Product Change Notification

Date Issued :	November 24, 2023	PCN Number :	514599
Reason for Change :	Change to Product		
Description of Change :	This notification is to inform you about changes that are being made to the part(s) as identified in the list. This change will not affect the Fit, Function, there is slight change in form or appearance of the parts. Or it may result in a change to the specification or raw material.		
Reason for Short Notice :	Special Request		
Assessment of Change :	First Article Inspection		
Planned Implementation Date :	December 22, 2023		
Sample Availability Date:	November 28, 2023		
Internal Molex Qualification Date :	November 30, 2023		
Last date to request Samples by Customer :	December 08, 2023		
Traceability Code Markings / Date :	Product made after planned implementation date can contain the change

Before Picture

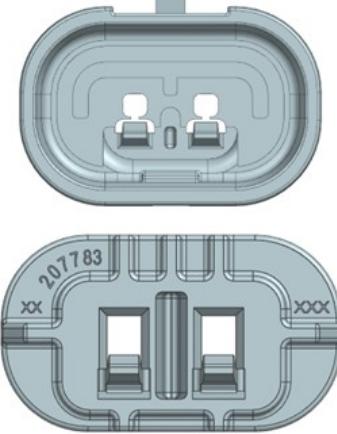
Before Modification

- Customer identified reverse mating of Squuba 3.6 W/O KEY connectors.

- PLUG HOUSING(2077790002/3/4)
- RECEPTACLE HOUSING (2077830002/3/4)

➤ To avoid this issue the below changes have been made :

- A rib has been added to PLUG HOUSING (2077790002/3/4)

- The rib has been modified in RECEPTACLE HOUSING (2077830002/3/4)
